SUBJECT: SAN ONOFRE NUCLEAR GENERATING STATION (SONGS) UNITS 2 AND 3:
REQUEST FOR RELIEF FROM REQUIREMENTS OF THE AMERICAN
SOCIETY OF MECHANICAL ENGINEERS (ASME) BOILER AND PRESSURE
VESSEL CODE (CODE) CONCERNING INSERVICE INSPECTION (ISI)
PROGRAM UPDATES FOR THE THIRD 10-YEAR INSPECTION INTERVAL
(TAC NOS. MC0334 AND MC0335)

SAFETY EVALUATION BY THE OFFICE OF NUCLEAR REACTOR REGULATION

REQUESTS FOR RELIEFS ISI-3-2 THROUGH ISI-3-5

SAN ONOFRE NUCLEAR GENERATING STATION (SONGS), UNITS 2 AND 3

SKETCH 4-1

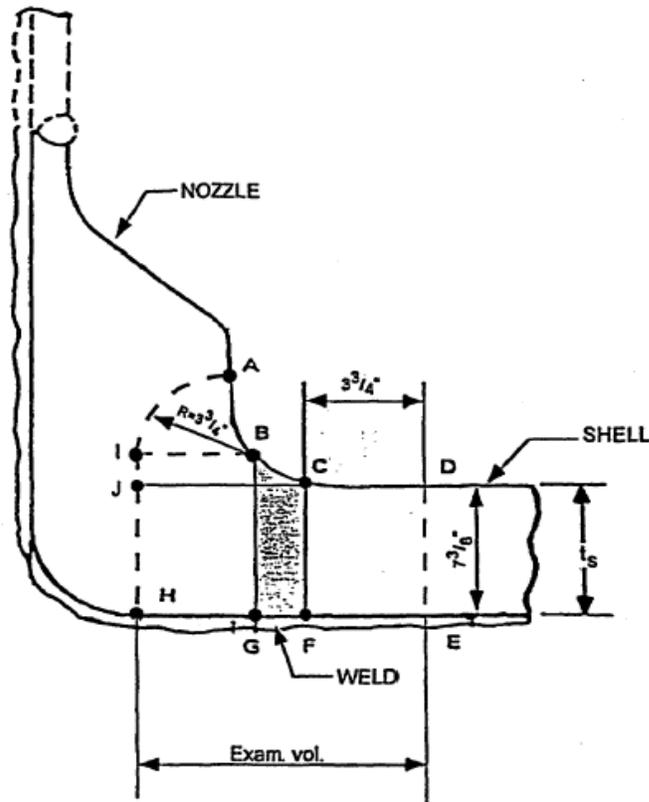
The Code requires volumetric examination for volume A-B-C-D-E-F-G-H-I as shown on Figure IWB-2500-7. The licensee requests relief from performing the Code-required 100 percent volumetric examination for the following of nozzle-to-vessel welds.

In lieu of the Code requirements, the licensee proposed to perform ultrasonic testing (UT) of volume D-E-H-J (Sketch 4-1).

To achieve full UT coverage of the whole volume required by the Code, examination has to be performed on the shell side to scan Volume D-E-H-J (Sketch 4-1) and on the nozzle side to scan volume A-B-C-J. The nozzle design of the San Onofre pressurizer and steam generator has a geometric configuration that precludes achieving the required volume A-B-C-J.

The Code requires volumetric examinations of pressurizer and steam generator nozzle-to-vessel welds. However, the SONGS Units 2 and 3 pressurizer and steam generator nozzles have a geometric configuration that precludes achieving 100 percent of the required examination from the outside. The design configuration restrictions make the Code-required volumetric examination impractical. To obtain complete volumetric coverage, modification of the components would be required. Imposition of this requirement would cause a considerable burden on the licensee.

The licensee proposed no additional examinations. However, based on the significant amount of volumetric coverage that has been obtained, it is reasonable to conclude that a pattern of degradation, if present, would have been detected. Thus, reasonable assurance of structural integrity and an acceptable level of quality and safety is provided.

Based on the above evaluation, the staff concludes that the design configuration restrictions make the Code-required volumetric examination impractical. Based on the significant amount of volumetric coverage obtained, reasonable assurance of structural integrity and an acceptable level of quality and safety has been provided. Therefore, relief is granted pursuant to 10 CFR 50.55a(g)(6)(i) for the third 10-year ISI interval at SONGS Units 2 and 3. The staff has determined that relief is authorized by law and will not endanger life or property, or the common defense and security and is otherwise in the public interest giving due consideration to the burden upon the licensee that could result if the requirements were imposed on the facility.
